Access Compliance Report Public Rights-of-Way (Curb Ramps)

Main Street: HARRISBURG_RD Cross Street: KITTRICK_DR Location: W

ADA ID: RPAT211202091930 Ramp Type: Type 1 - Perpendicular Diagonal Initial Pass/Fail: Fail Overall Compliance: No Severity Score: 15

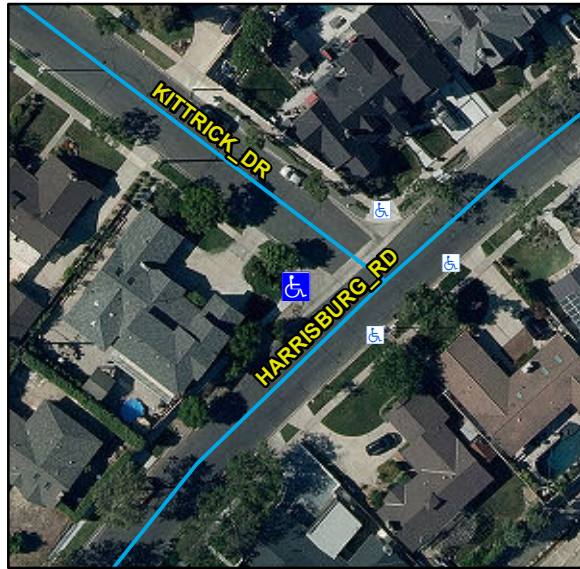
R304.2.2, R204.3, STD 1115

Compliance	Description	Data	Compliance	Description	Data
N/A	Ramp Length (in)	81	N/A	Flare Type LT	
Yes	Ramp Width (in)	48			N/A
No	Ramp Run Slope (%)	9.1	N/A	Flare Slope LT (%)	N/A
Yes	Ramp Cross Slope (%)	0.3	N/A	Flare Traversable LT	N/A
N/A	Landing Present	N/A	N/A	Flare Type RT	
N/A	Landing Length (in)	N/A			N/A
N/A	Landing Width (in)	N/A	N/A	Flare Slope RT (%)	N/A
N/A	Landing Run Slope (%)	N/A	N/A	Flare Traversable RT	N/A
N/A	Landing Cross Slope (%)	N/A	N/A	DWS Provided	N/A
N/A	Landing Movement Obstructed?	N/A	N/A	DWS Contrast	N/A
	Landing Movement Type	N/A	N/A	DWS Length (in)	N/A
N/A	Landing Shared	N/A	N/A	DWS Full Width	N/A
N/A	Clear Space	Yes	N/A	DWS Offset Left (in)	N/A
N/A	Clear Space To Crosswalk (in)	N/A	N/A	DWS Offset Right (in)	N/A
N/A	Marked Crosswalk 1	No	N/A	Marked Crosswalk 2	No
	Crossing 1 Direction	SE		Crossing 2 Direction	NE
	Marked Crosswalk 1 Width (in)	N/A		Marked Crosswalk 2 Width (in)	N/A

Remove & Replace Curb Ramp With Two New Directional Ramps or Equivalent.
